BID
ADDENDUM NO. 3
TO
CONTRACT DOCUMENTS
AND
TECHNICAL SPECIFICATIONS
FOR
2019 BOND REFERENDUM
CAPITAL IMPROVEMENTS
AT
MAMARONECK HIGH SCHOOL
PHASE 2
NYSED #66-07-01-03-0-001-039
BID # 20/21 – MUFSD-00

Mamaroneck Union Free School District
1000 West Boston Post Road
Mamaroneck, NY 10543

LAN Job #4.1092.72.06
January 7, 2022

UNAUTHORIZED ALTERATIONS OR ADDITIONS TO THIS DOCUMENT IS A VIOLATION OF SECTION 7209 OF THE NEW YORK STATE EDUCATION LAW. THESE DOCUMENTS REMAIN THE EXCLUSIVE PROPERTY OF THE ENGINEER, AND MAY NOT BE USED FOR ANY PURPOSE WHATSOEVER WITHOUT THE WRITTEN CONSENT OF THE ENGINEER.

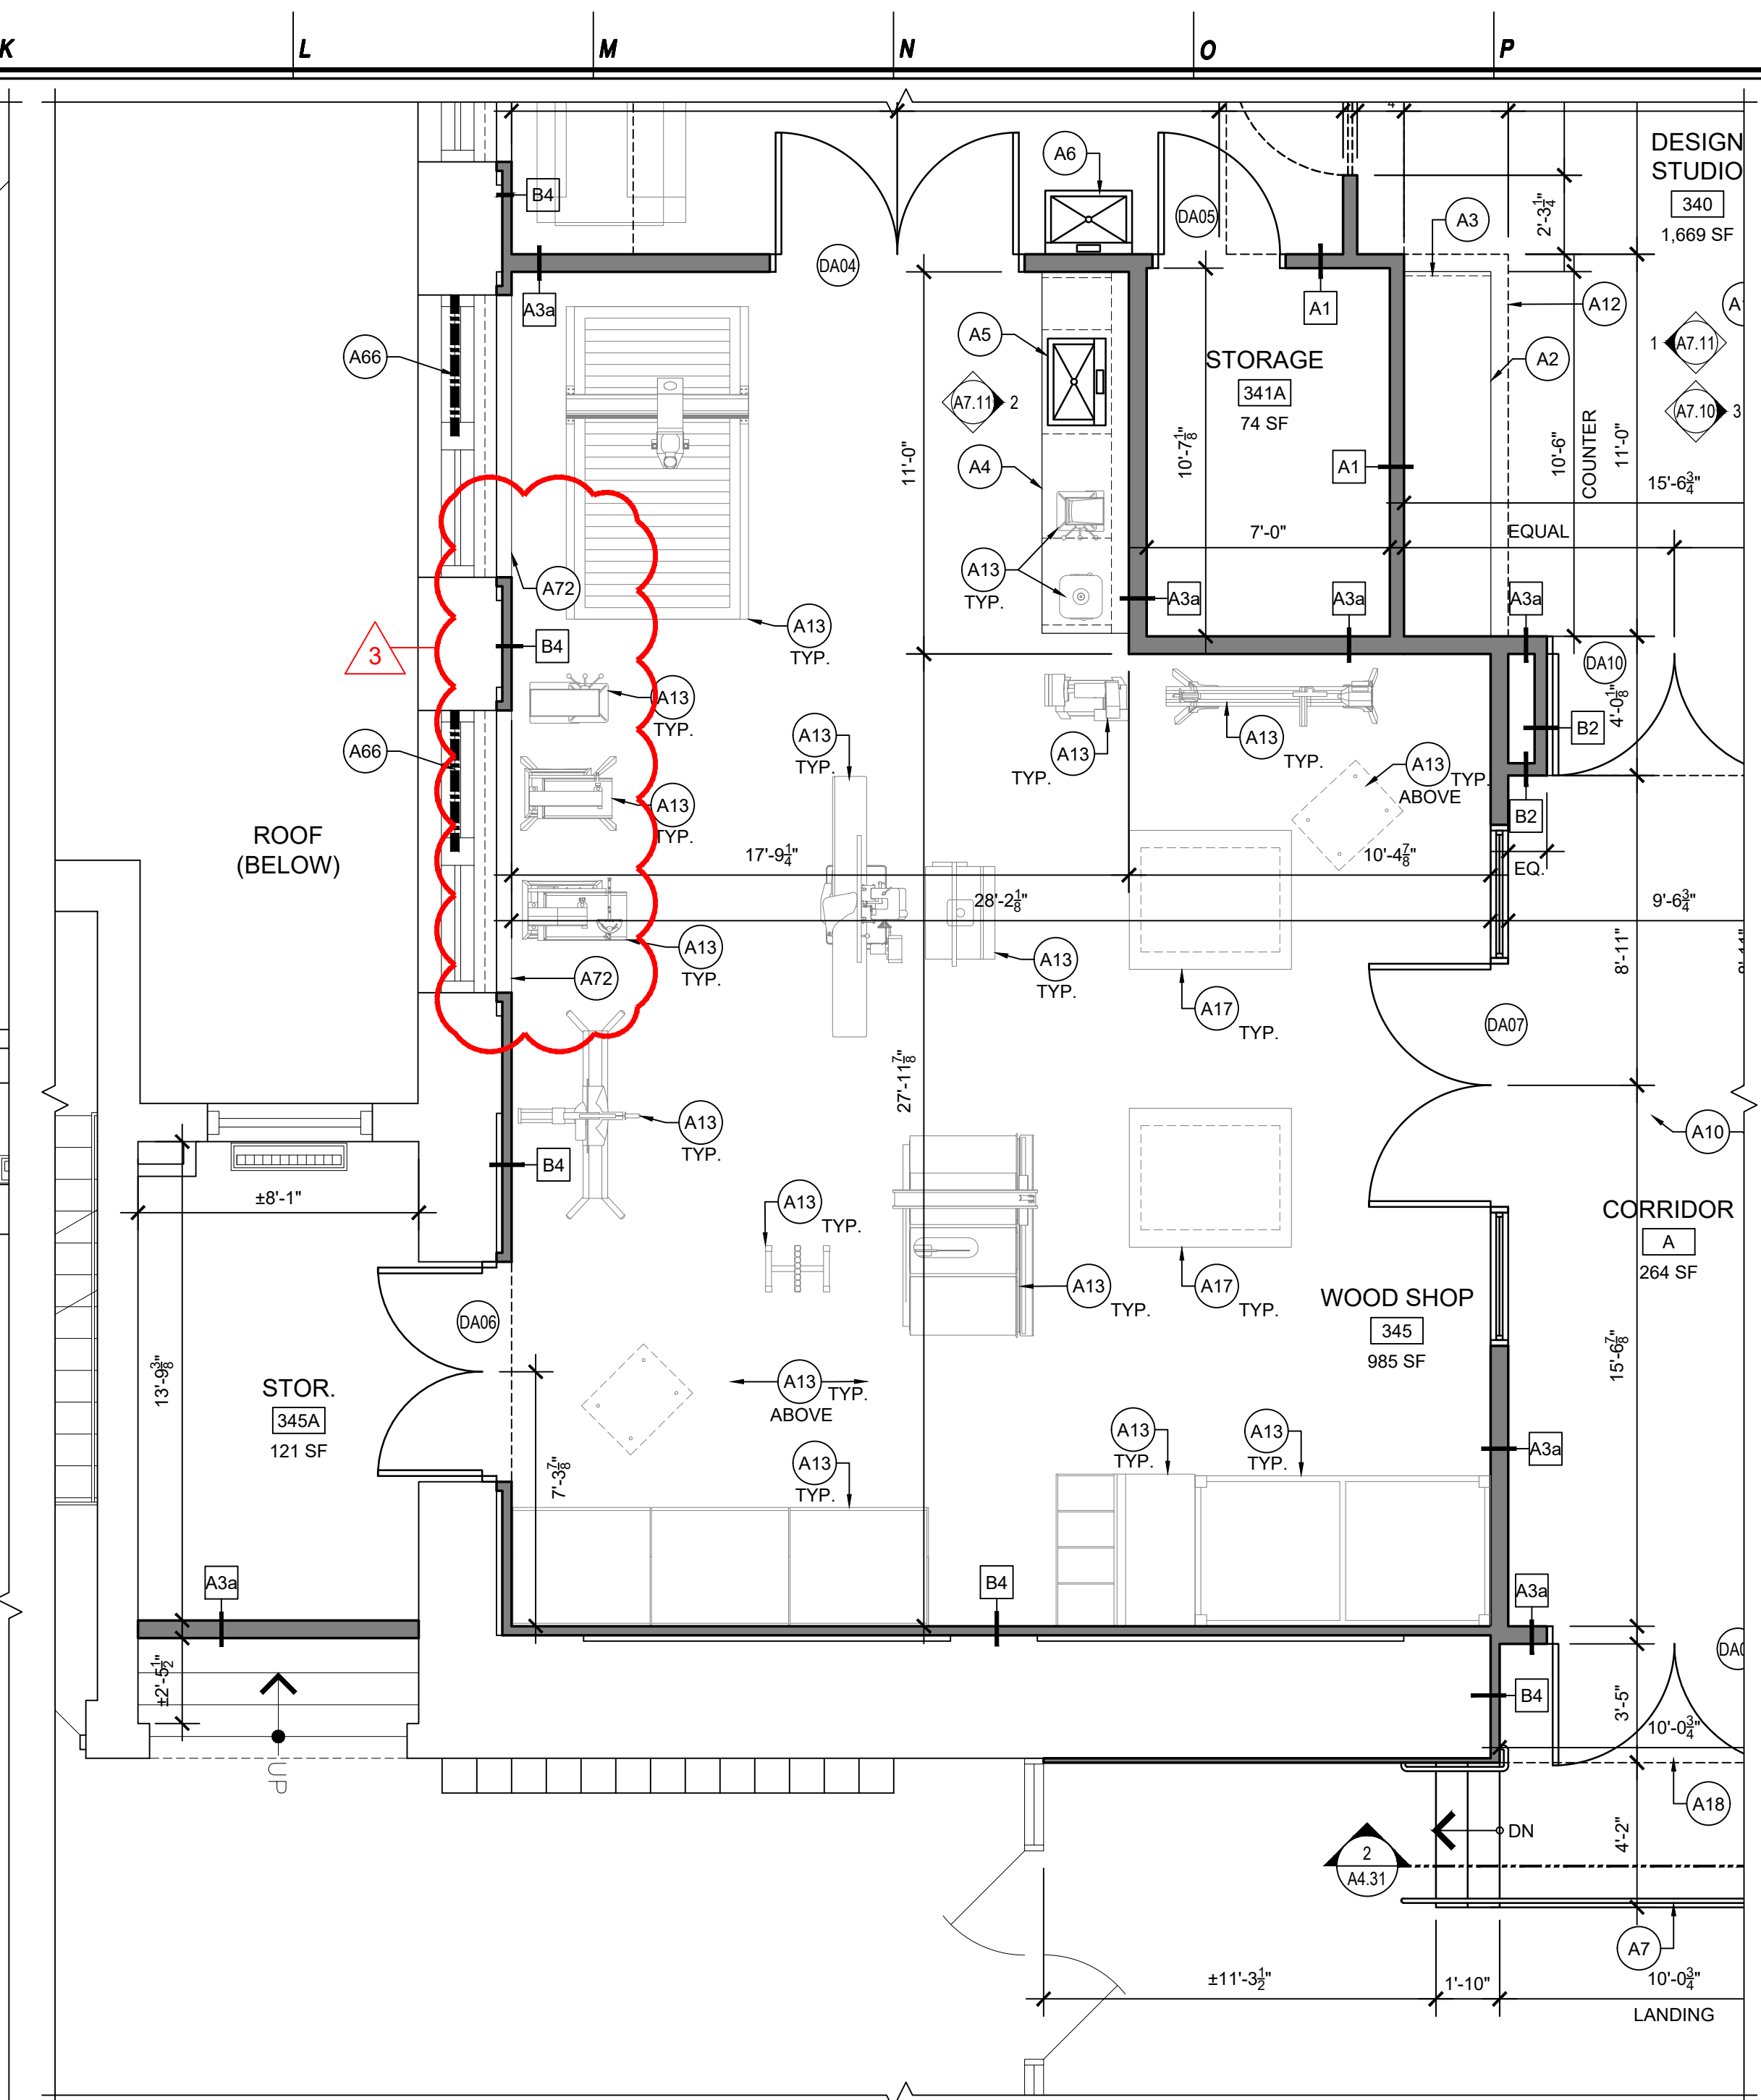
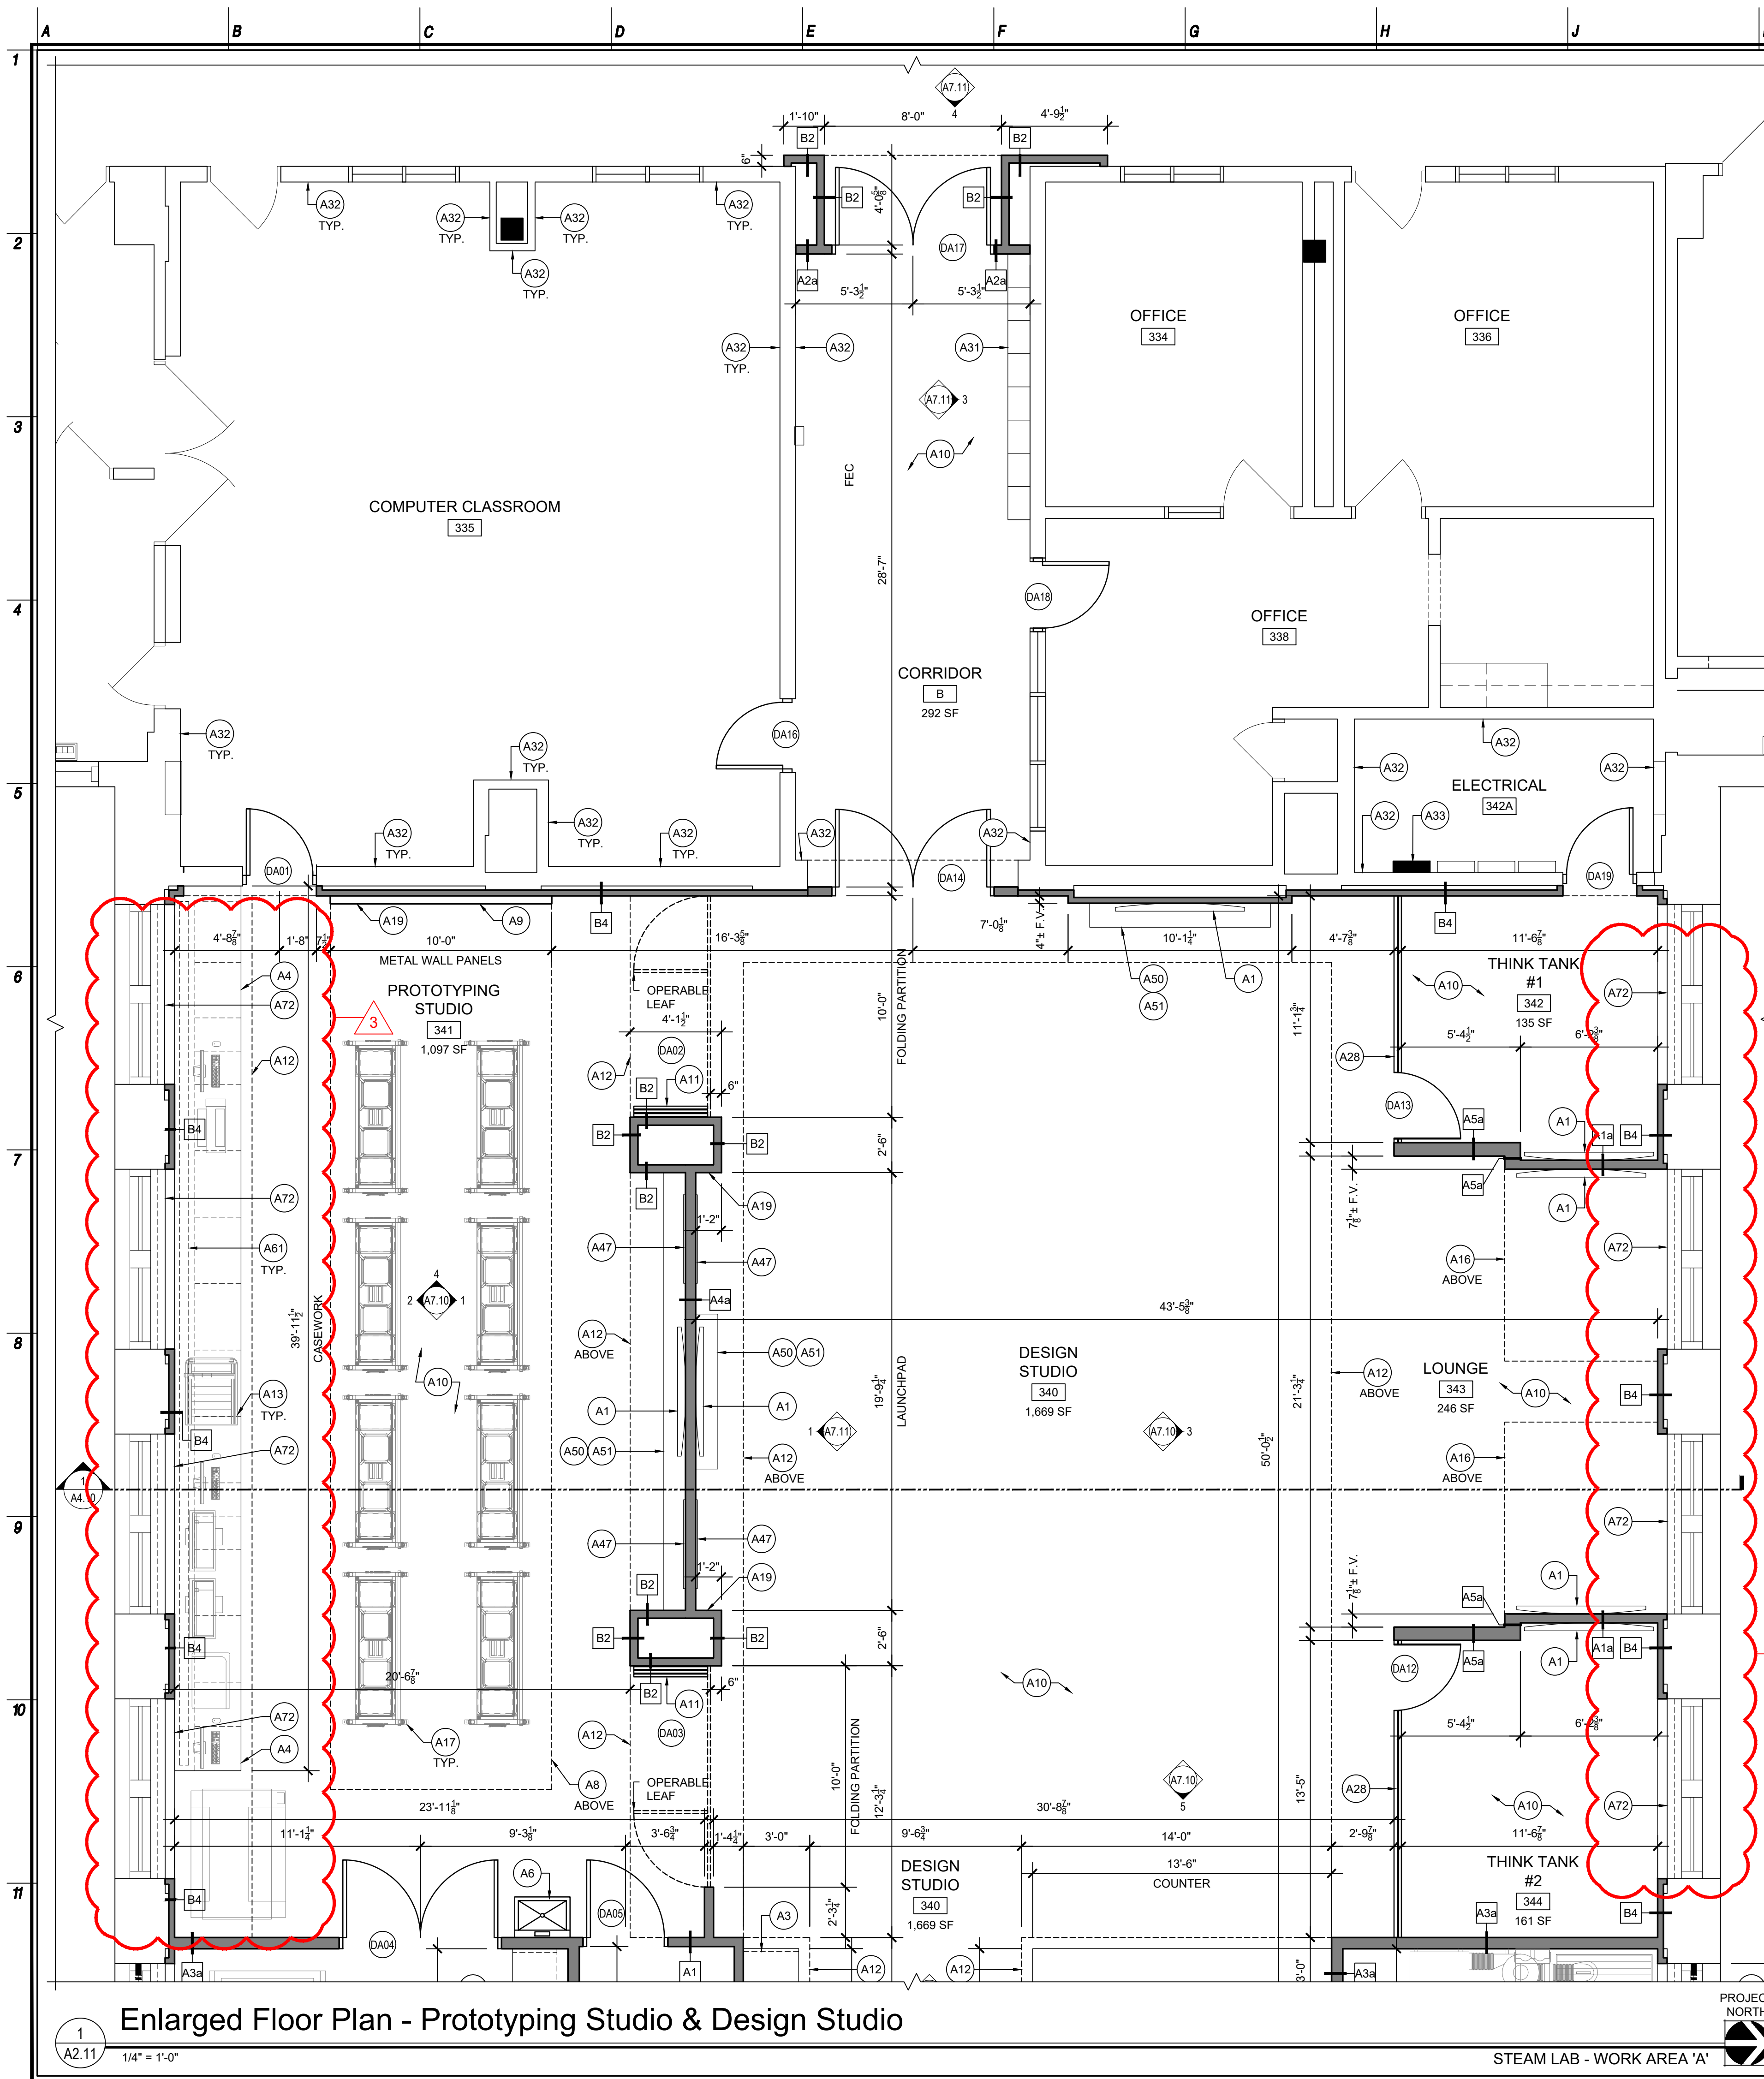
Drawing No.	Addendum Requirements
A0.01	Work Area 'P' – Dunnage Painting (Various Work Areas) has been added to the SCOPE OF WORK AREAS/ITEMS list as well as the Dunnage Painting Note below it.
A0.02	Work Area 'P' – Dunnage Painting (Various Work Areas) has been added to the SCOPE OF WORK AREAS/ITEMS list as well as the Dunnage Painting Note below it.
A2.01	Drawing updated to reflect convector covers to be painted by the GC.
A2.11	Drawing updated to reflect convector covers to be painted by the GC.

- 7 Question: As discussed in the walkthrough the Existing Dunnage Scraping and Painting is to be performed by the GC. After review of the following Contract Drawings, M2.71 includes the following note, "Insert Note GC to scrape and Paint Steel Dunnage" and in addition refer to M2.91, Demo and Construction Key Notes 1, 2 & 4. Please confirm if any portion of this work including Alternate 6B-2 is to be provided by the General Contractor.

- Response: Painting of the dunnage shall be by the GC. Refer to updated drawings A0.01, A0.02, M2.71, and M2.91.
- 8 Question: Please refer to Contract Drawing M2.11, FD/SD is indicated on the plan in several locations. Please refer to M0.01 where FD/AD and FSD/AD symbols are indicated. Please clarify the desired assembly to be provided on M2.11.

DUNNAGE PAINTING NOTE (WORK AREA "P"):
 THE GC SHALL BE RESPONSIBLE FOR SCRAPING, PRIMING, AND PAINTING THE EXISTING DUNNAGE AS OUTLINED ON DRAWINGS M2.71 & M2.91. GC SHALL PROVIDE (1) PRIMER COAT & (2) FINISH COATS OF PAINT. COLOR PER OWNER'S SELECTION. REFER TO SPECIFICATION SECTION 099113 - EXTERIOR PAINTING FOR ADDITIONAL INFORMATION.
